## ORIGINATION FORM

### Proposed Revisions to a Standard Plans Index

Index Number: 509-070

Index Title: Railroad Grade Crossing Traffic Control Devices

MEDIAN SECTION AT SIGNAL GATES

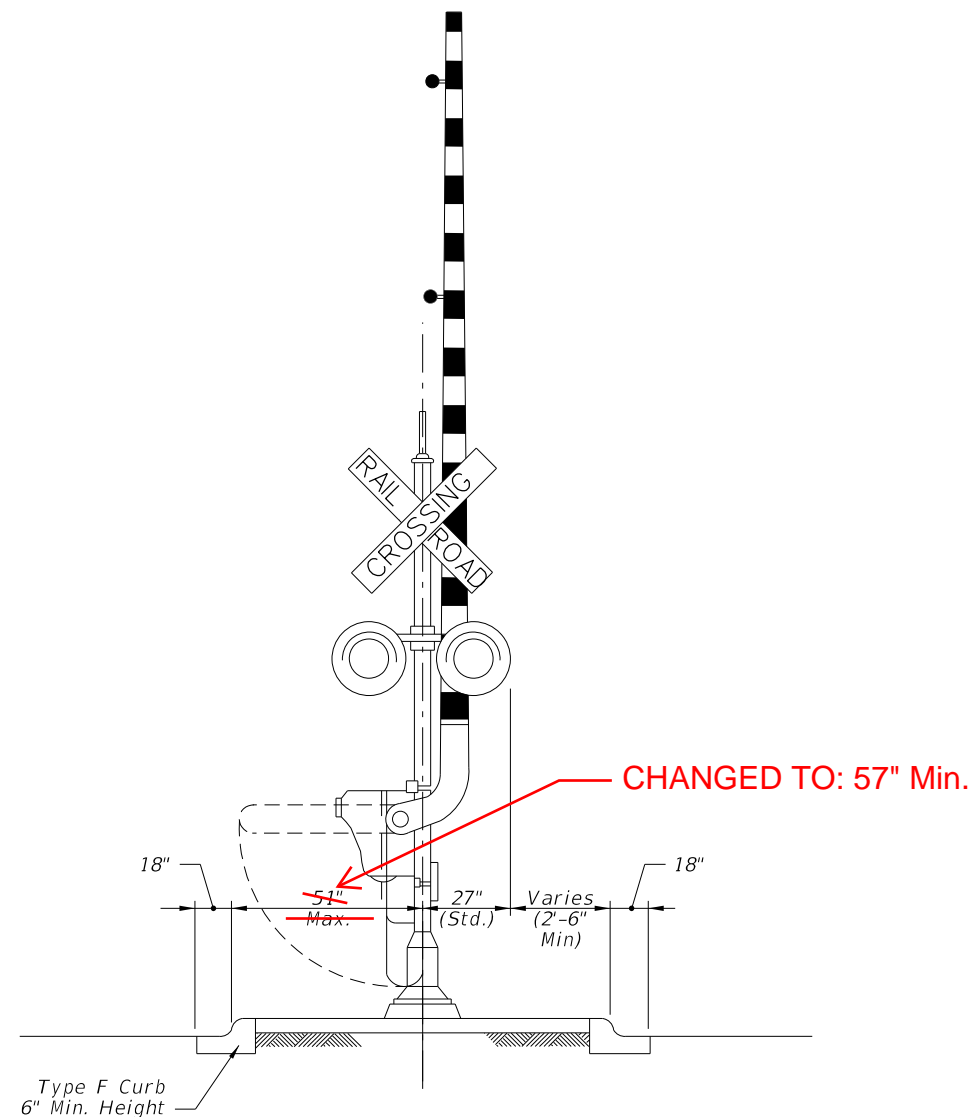
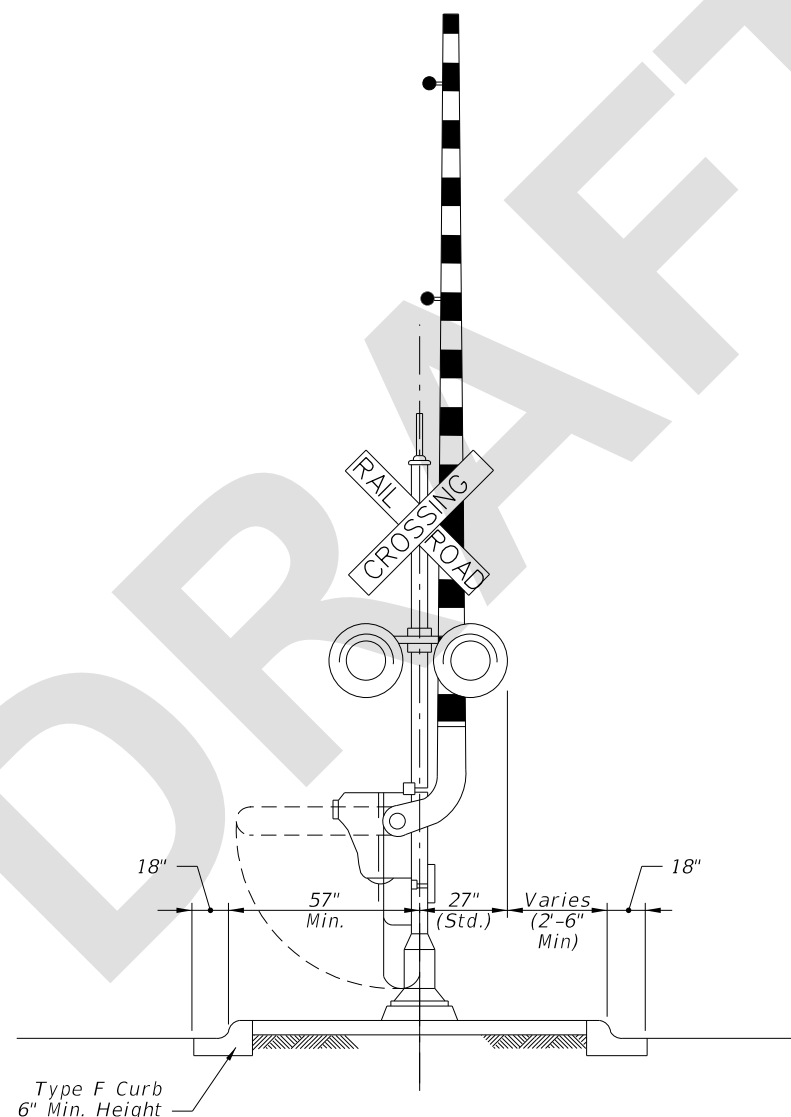
Sheet 3: Change 12'-5" min to 12'-6" Min. in PLAN; Change 51" Max to 57" Min in Median Section at Signal Gates Detail.
